**STAFF REPORT  
URBAN DESIGN COMMISSION  
CITY OF FORT WORTH, TEXAS**

<b>REQUEST</b>	Certificate of Appropriateness
<b>APPLICANT/AGENT</b>	Jeff Van Curen/ Halbach Dietz Architects
<b>LOCATION</b>	6905 Camp Bowie Blvd.
<b>ZONING</b>	CB-GC

The applicant requests a Certificate of Appropriateness for a waiver from the Camp Bowie Revitalization Code Standards and Guidelines to allow the following:

Fig. 3 – First floor plan showing the street-facing portion of the theater in red. This length is approximately 43 ft.

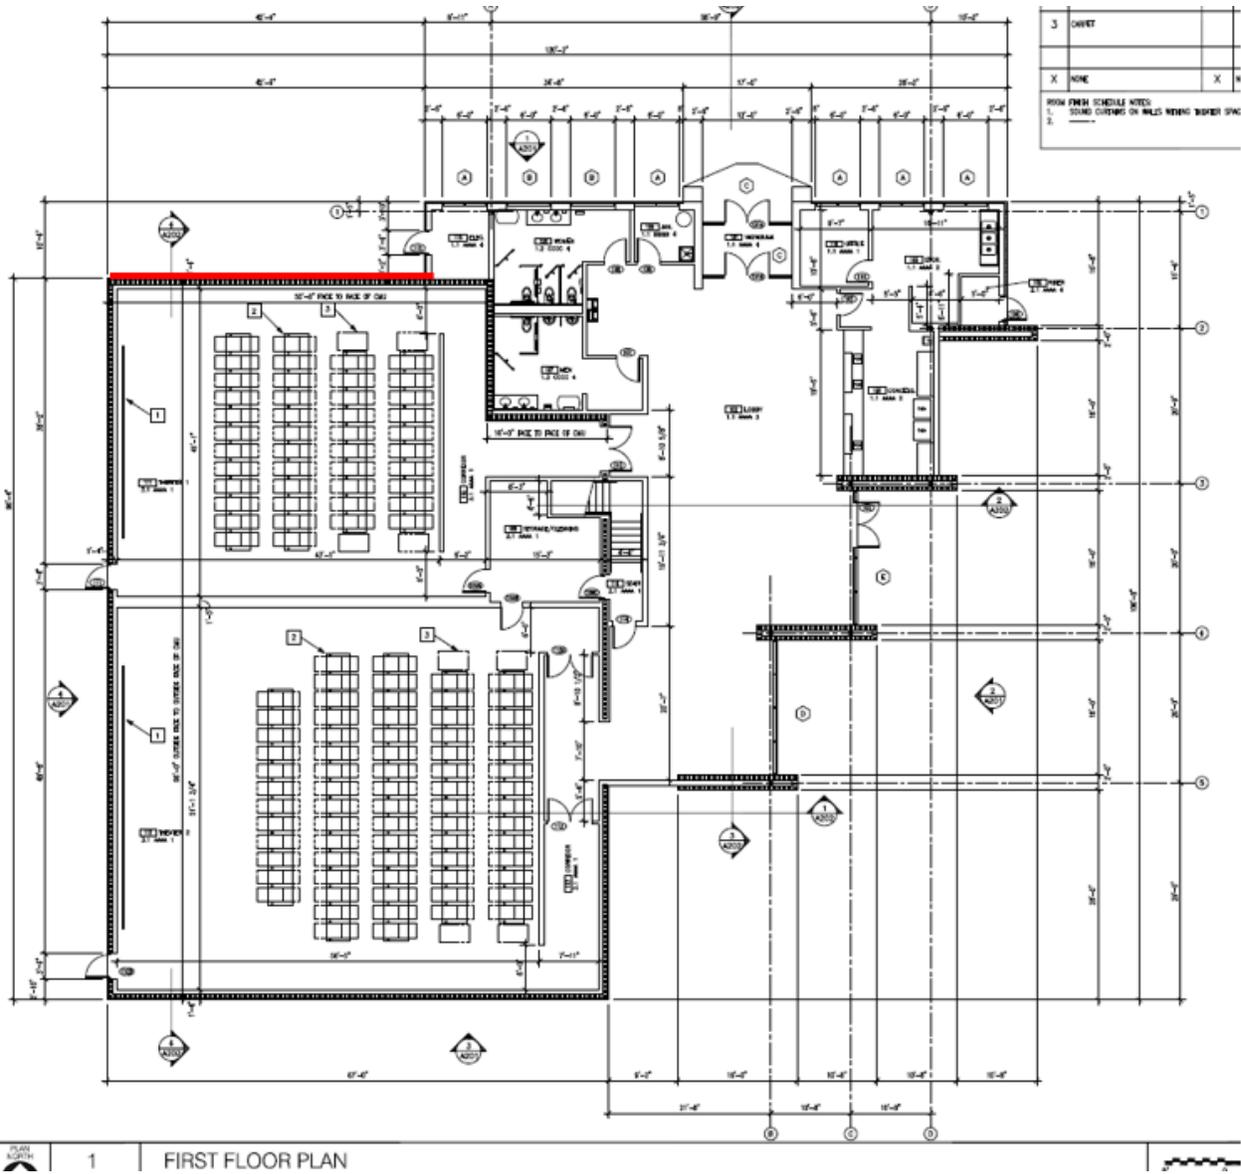
The proposed project has front entrances and a main lobby and plaza area oriented toward Camp Bowie boulevard. The layout for the site and interior plan shows two theaters with seating and screens oriented towards the west. This portion of the building, which is approximately 43 feet in length on the Camp Bowie side, has no fenestration. While this wing of the building is still highly visible from the street, the development is proposing to mitigate for the impact of the blank wall area. This wing of the project is set back approximately 10 feet behind the front wall and is partially screened with additional plantings, which soften the transition from the paved walkway to the blank façade. The applicant has also proposed to include additional treatments, such as a mural, on the Camp Bowie facing portion of the theater to provide additional activation. It should also be noted that although this is a midblock lot and additional activation is not required on facades that do not face Camp Bowie, the development is providing a large landscaped outdoor seating area on the east side of the property.

**That the request for a Certificate of Appropriateness for a waiver from the Camp Bowie Revitalization Code Standards waiver to allow the doors and window on the ground floor facing Camp Bowie Boulevard to be 20% of the façade area when a minimum of 30% of the façade area is required, be approved, subject to the following conditions:**

- 1. That more activation (including but not limited to public art) be provided on the Camp Bowie facing side; and**
- 2. That any adjustments made to the drawings be submitted to the Development Services Department prior to the issuance of a Certificate of Appropriateness.**
